**Village of Sackets Harbor**  
Brown Shores Road Pump Station Improvements  
BCA Project No. 2020-028

**Addendum No. 4**  
January 24, 2024

**1. Reference Sheet S-1:**

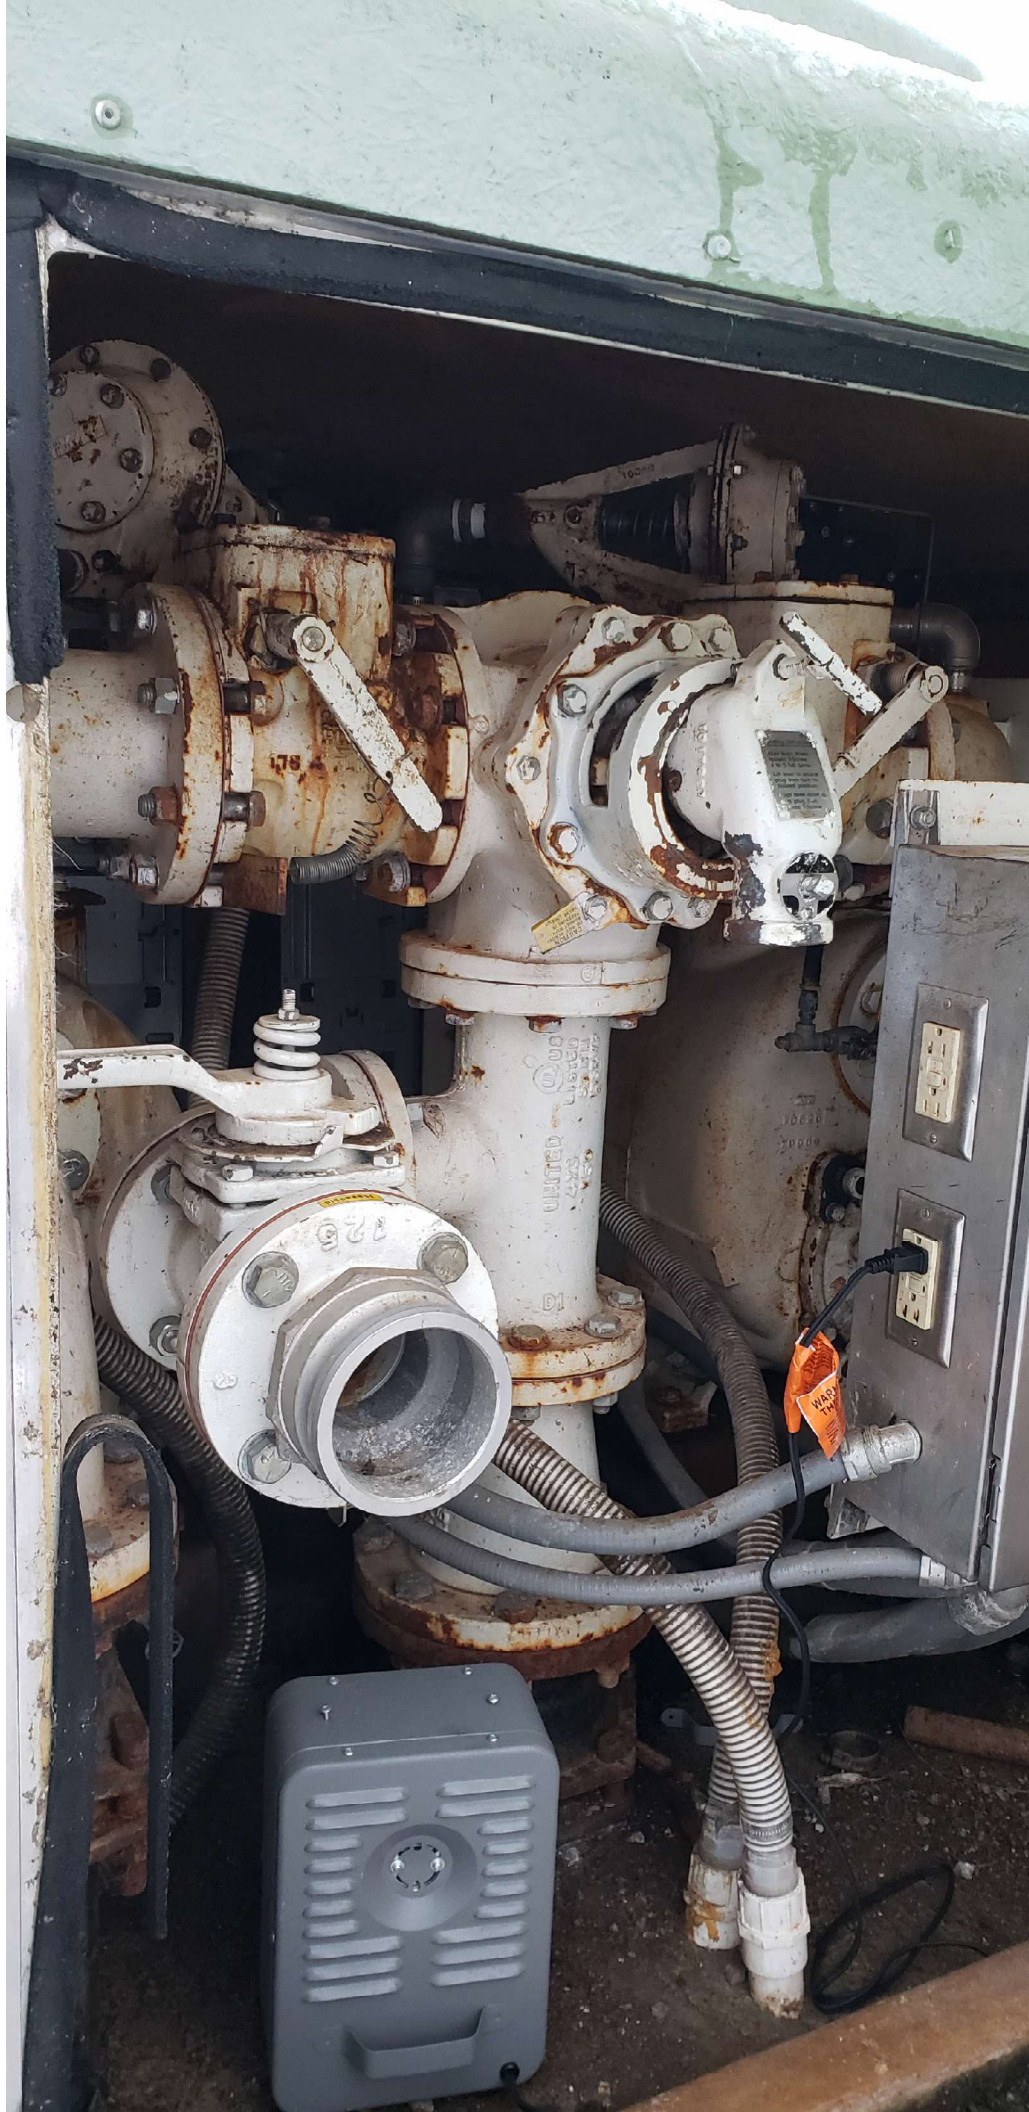
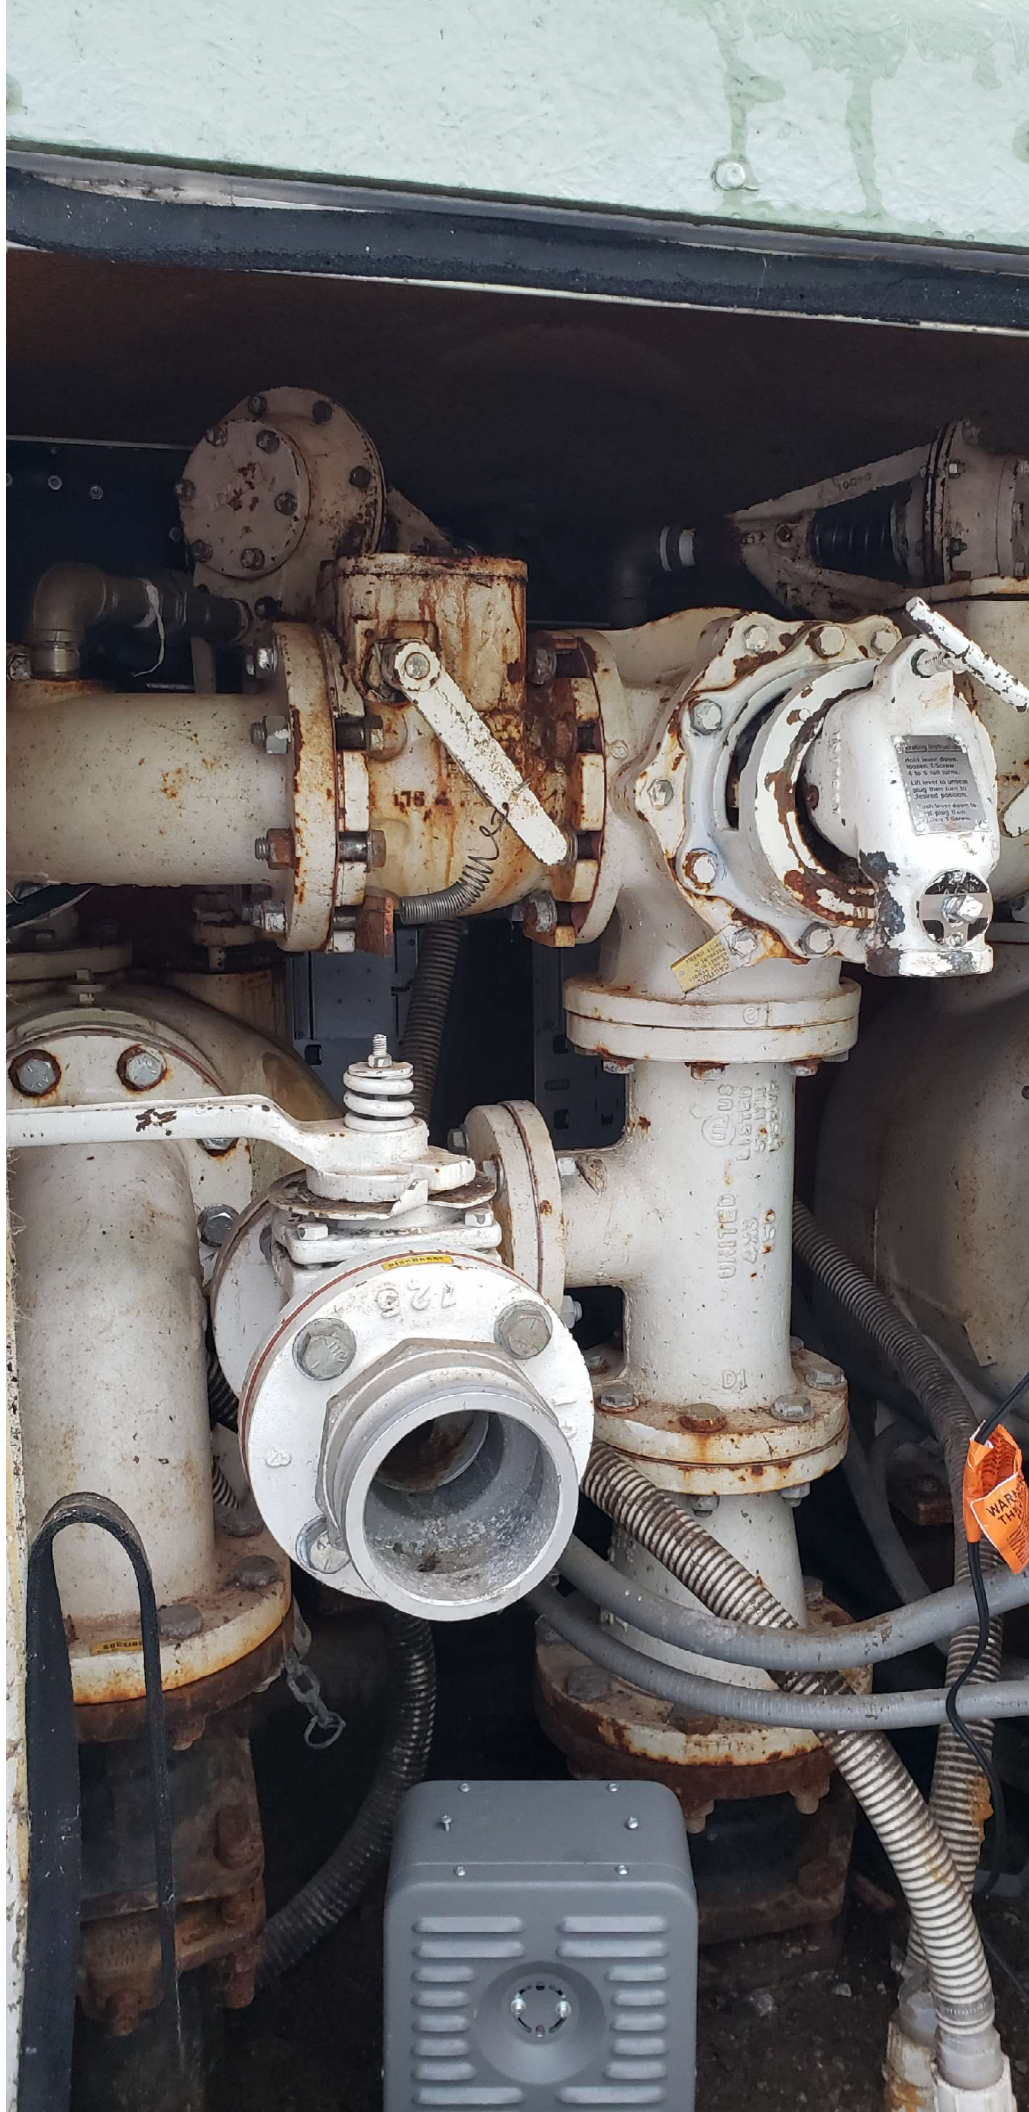
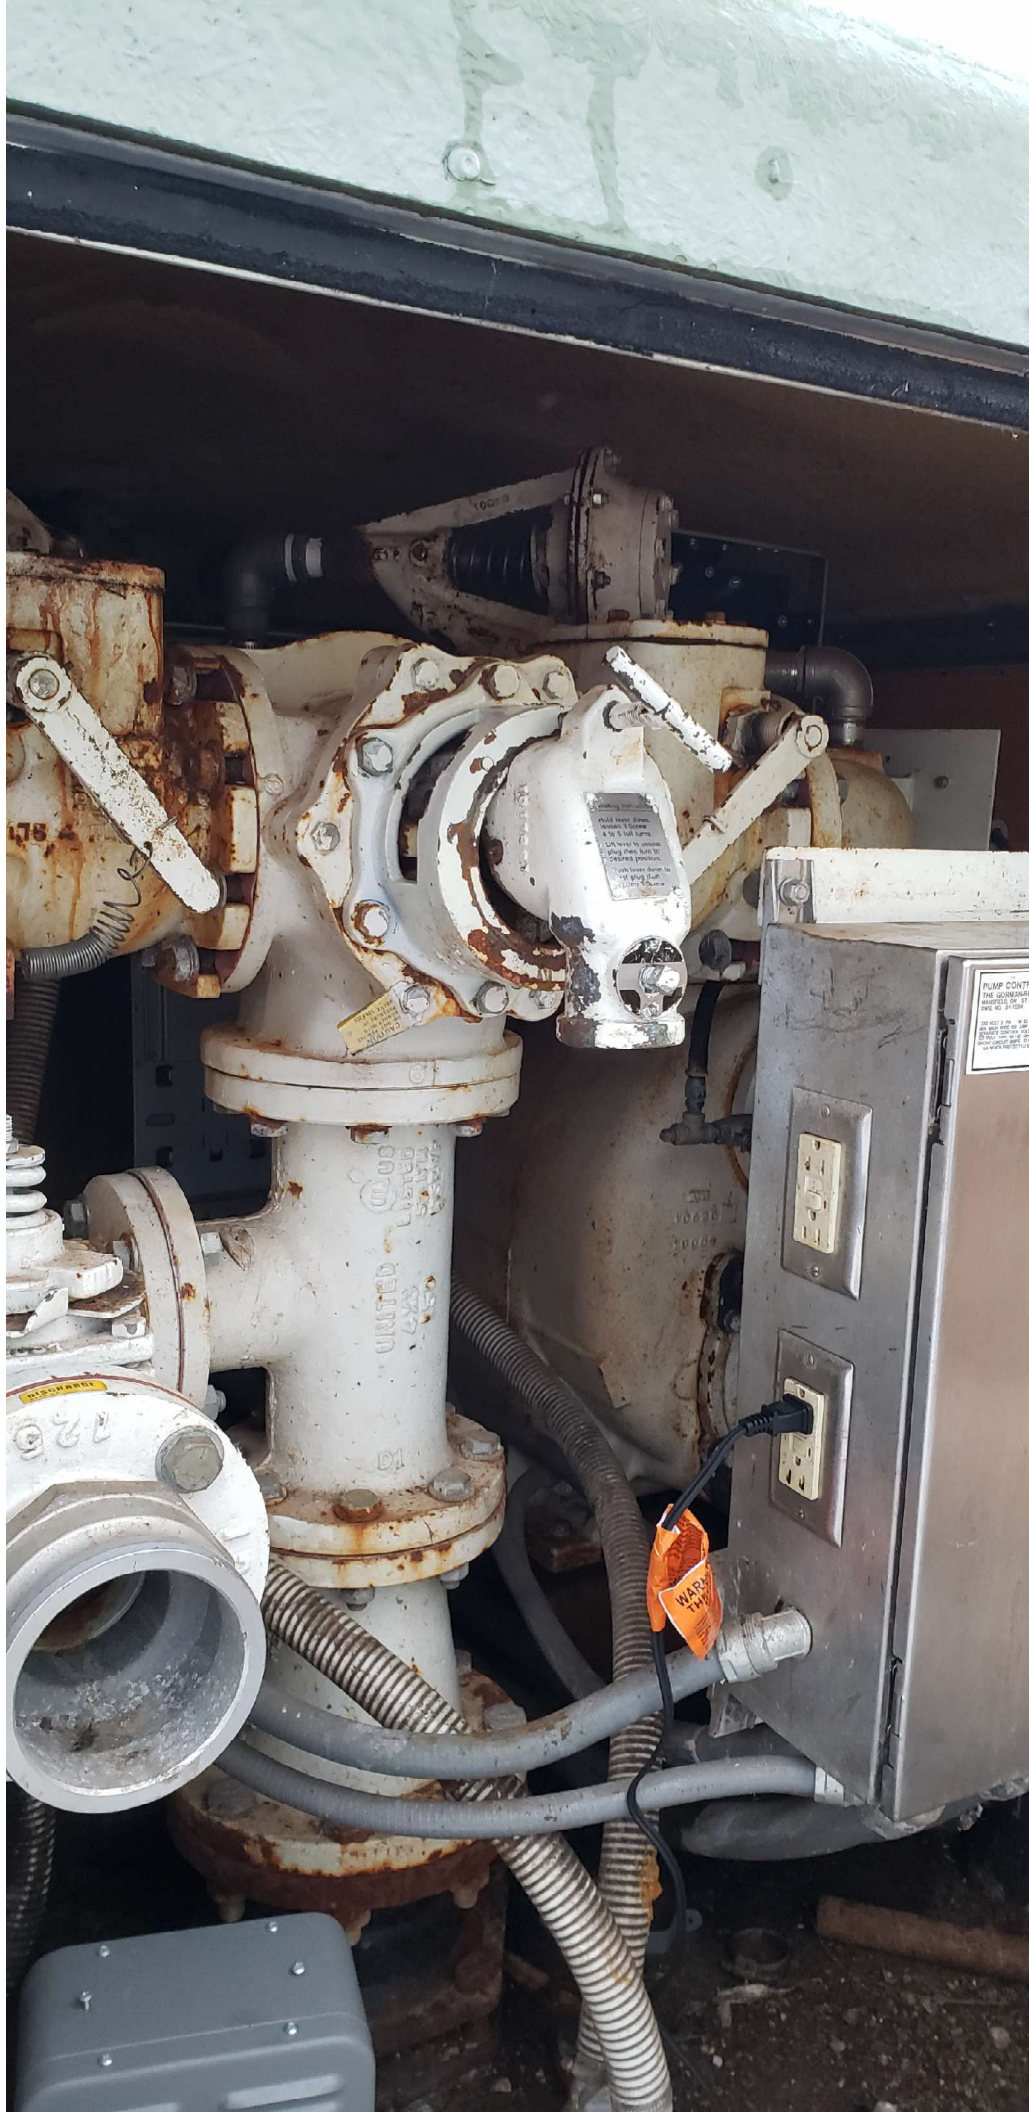
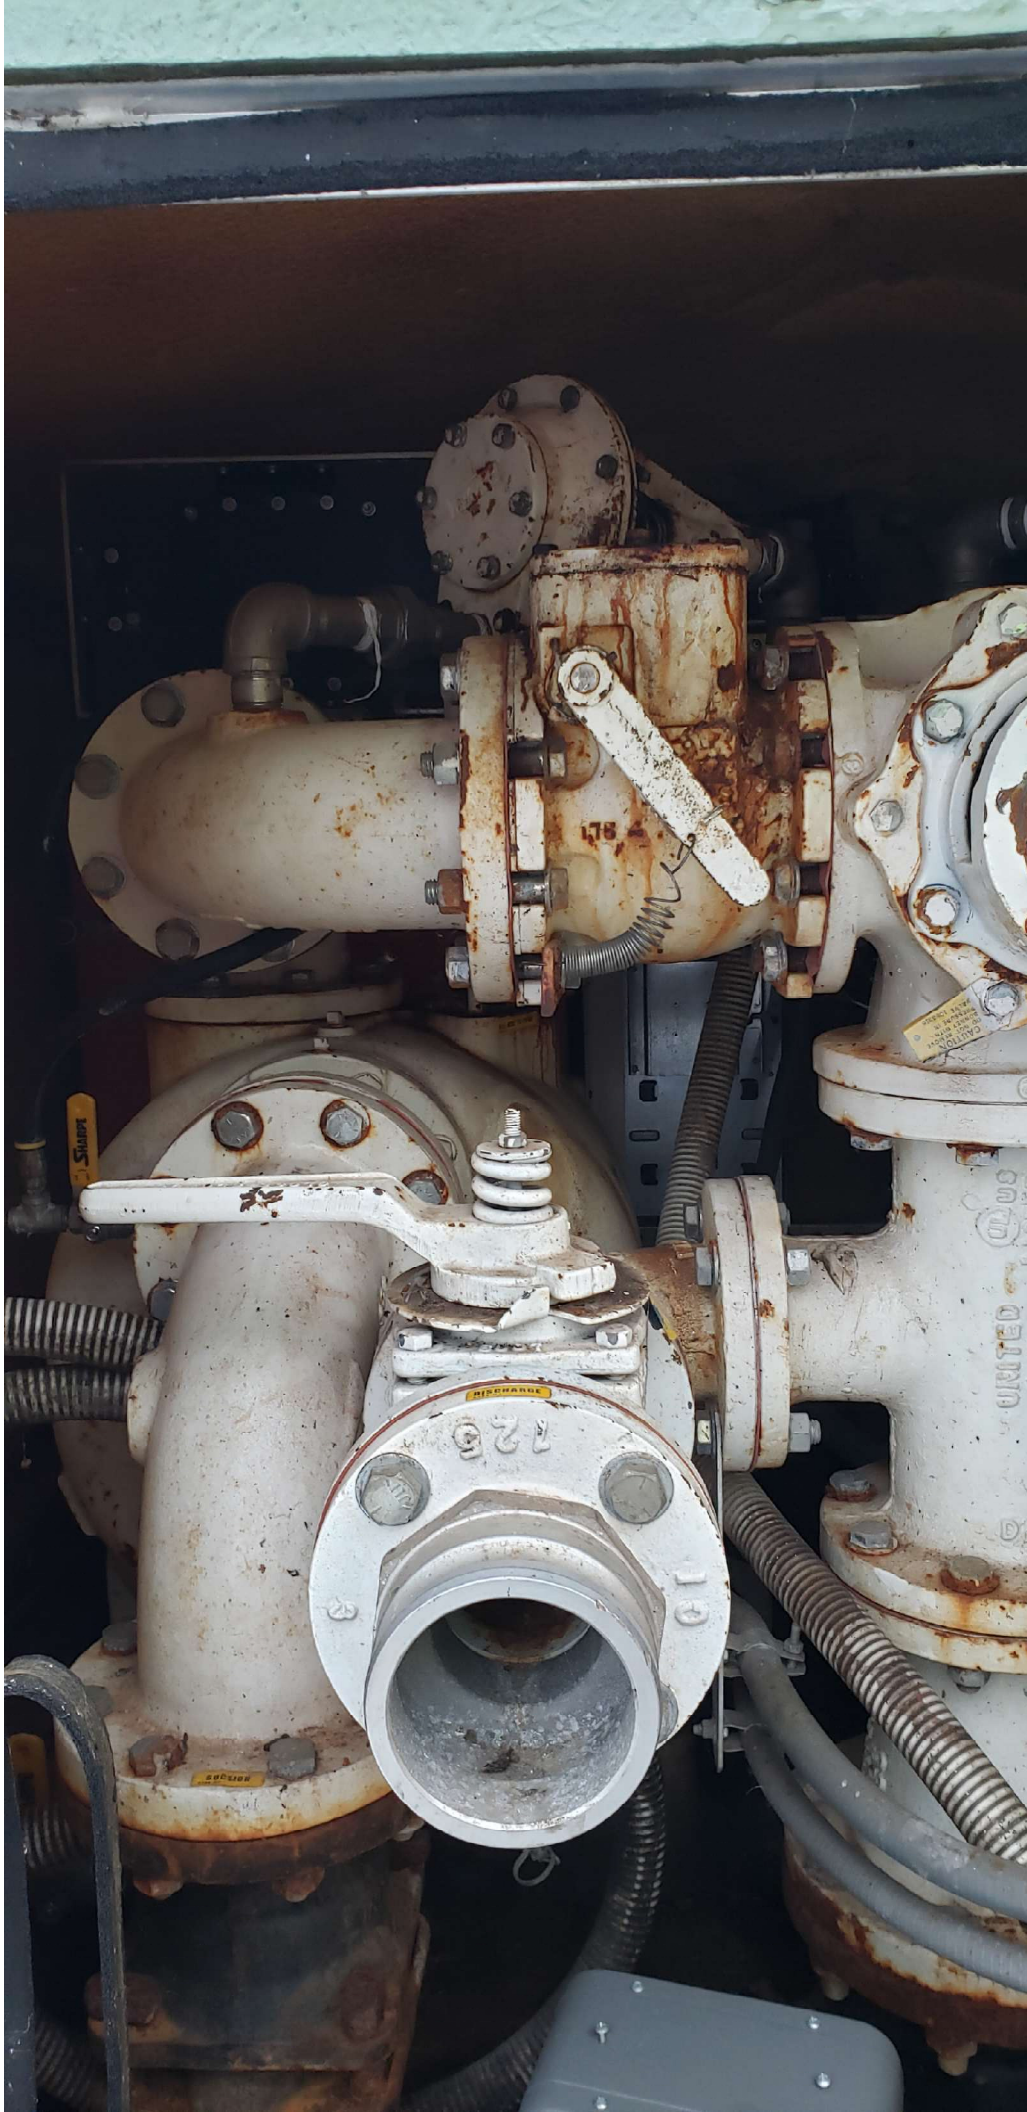
- a. Attached to this addendum are pictures of the existing pump(s)/piping configuration for reference.
